# MEMORANDUM

TO: City of Keizer Engineering Department  
FROM: Mike Towle, PE  
DATE: December 8, 2020  
SUBJECT: Chemawa Station Stormwater Design – Chick-fil-A Update

This memo outlines the proposed changes to the stormwater management facilities at the Chemawa Station development, originally designed by Westech Engineering in 2019.

**FIGURE 2**

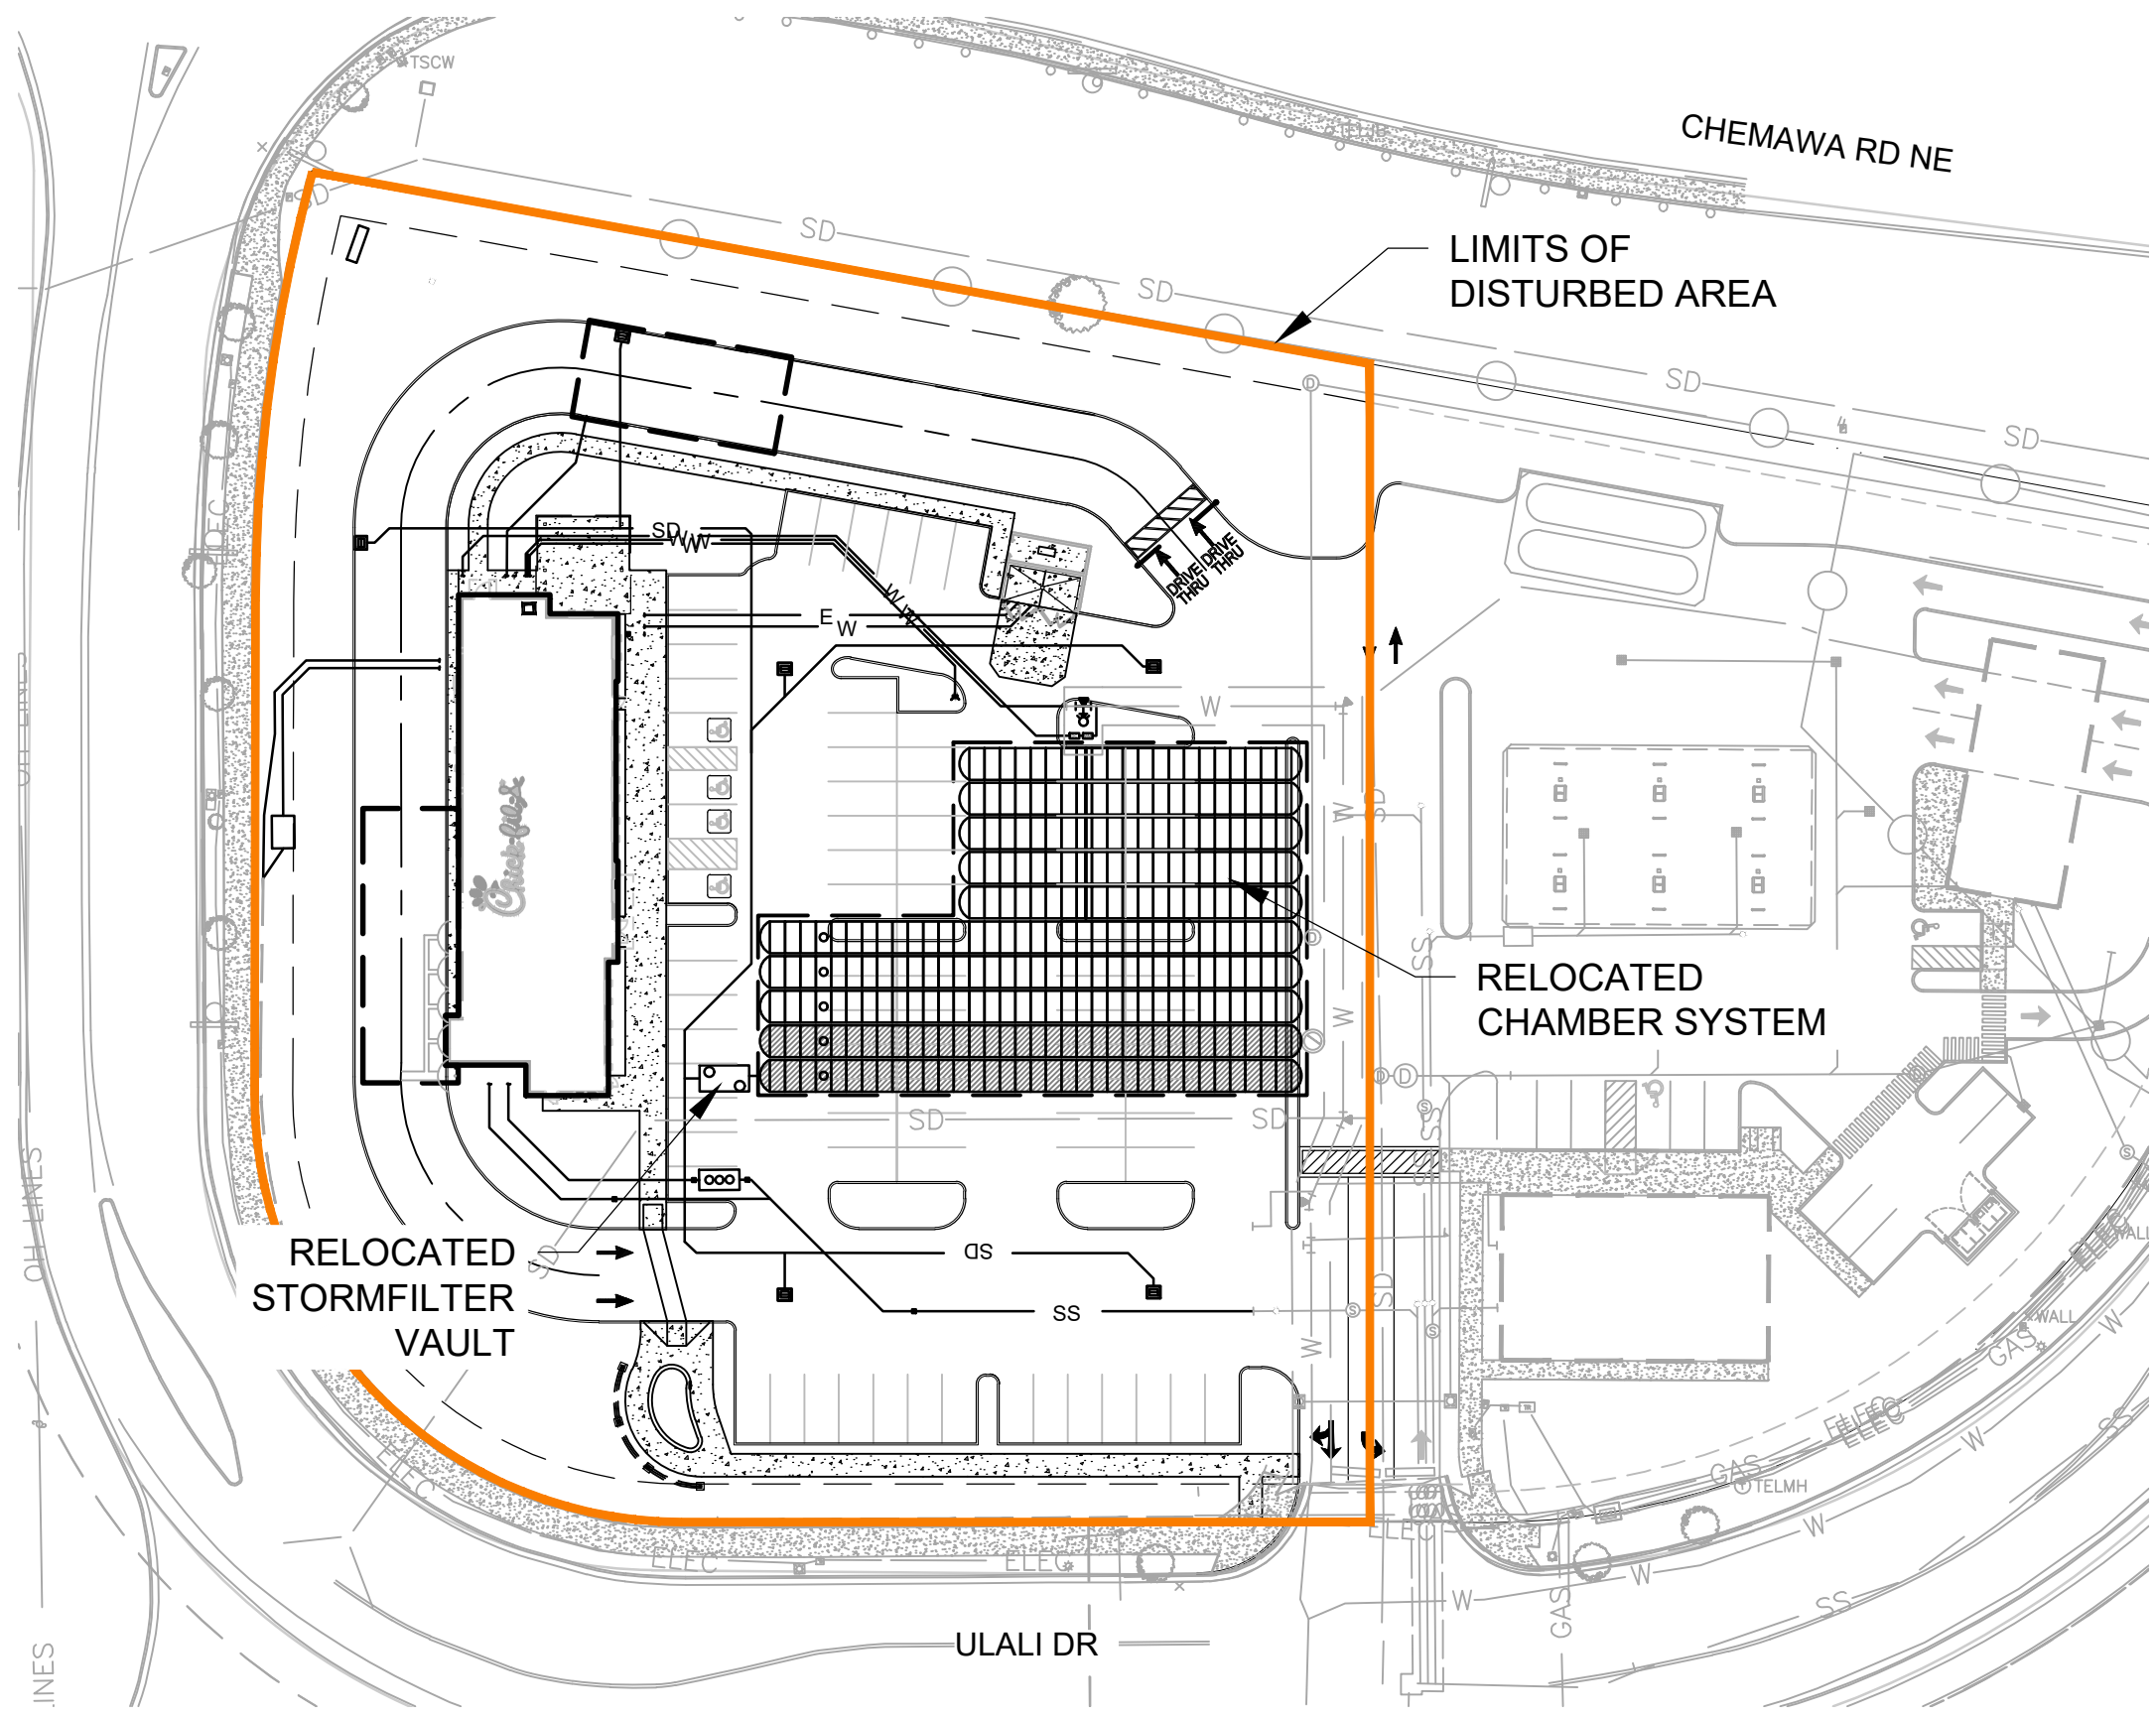
The proposed Chick-fil-A (CFA) site plan has modified the original site plan for the west side of the Chemawa Station development (referred to as “Basin West” by Westech). The building originally shown on the northwest side of the site has been moved to the west end of Basin West. The building originally shown on the southwest side of the site has been removed (See Attachments: Figure 2 – Proposed Conditions).

Due to this updated site plan, the previously installed stormwater treatment and detention facilities need to be relocated since they are now conflicting with the proposed building location. The stormwater design was checked to confirm the facility sizing is correct per the modified site plan. The original storm report was provided by Westech Engineering and was used to compare the new site conditions to the original design for this area.

The original design for the treatment and detention systems accounts for 1.76 ac of impervious area in Basin West. The proposed changes to the original design due to the new CFA layout results in 1.44 ac of impervious area within Basin West.

The new CFA layout has less impervious area than the original site layout, which means the water quality flow from the Basin West area decreased and the release rates from the detention system decreased. Therefore, the treatment and detention systems are adequately sized, and no additional filter cartridges or chambers are needed.

The attached exhibit shows the proposed new layout for the filter vault and chamber system. Please note, the final layout of these facilities is to be determined during the construction phase.
